LVIA ANALYSIS OF THE REQUEST FOR FURTHER INFORMATION

SUMMARY OF FI REQUEST ITEMS 3(b) and 3(c)

VIEW RECEPTOR no. 2 - AT ORIGINAL APPLICATION (enlargement)

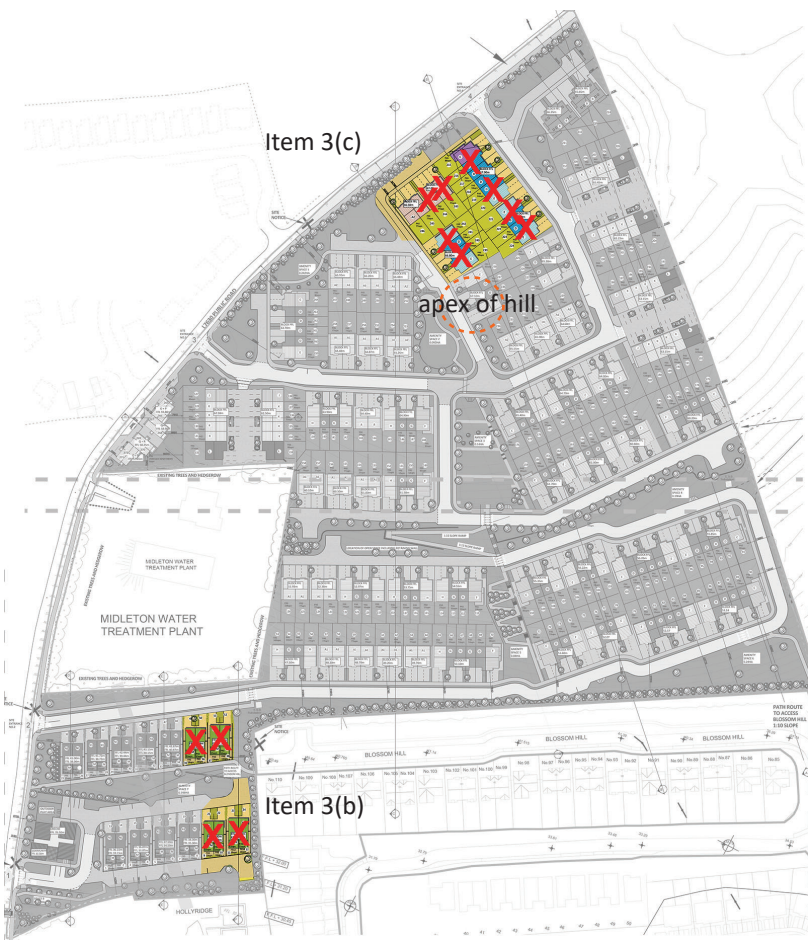
Part 3(b) - The omitted duplexes result in a greater visibility of the Sycamore tree row surrounding the water treatment facility. However, this tree row already stands proud. With the existing Steeples estate and negligible modifications to the ridgeline, the omissions results in no change to LVIA impact.

Part 3(c) - 18 no. houses have been omitted and the result is virtually imperceptible. The proposed removals occur to the background. Foreground ridgeline houses and trees remain as designed and form the new ridgeline. The recommended omissions are unnecessary from an LVIA perspective.
